Access Compliance Report

Public Rights-of-Way

Intersection ID: 3673	Main Street: KEENELAND_LN	Cross Street: DENALI_LN	Location: NW
ADA ID: 6C0192D9A6E0	Ramp Type: Perp	Initial Pass/Fail: Fail	Overall Compliance: No
		Severity Score: 8.75

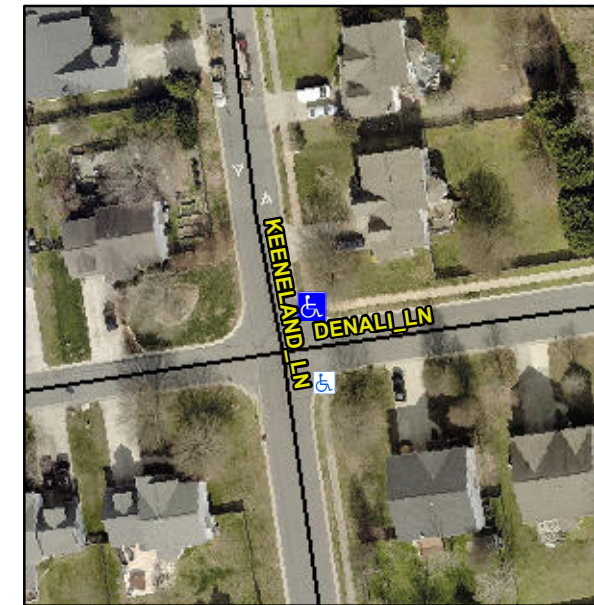
Not Found, R304.5.1

Remove & Replace Entire Ramp.
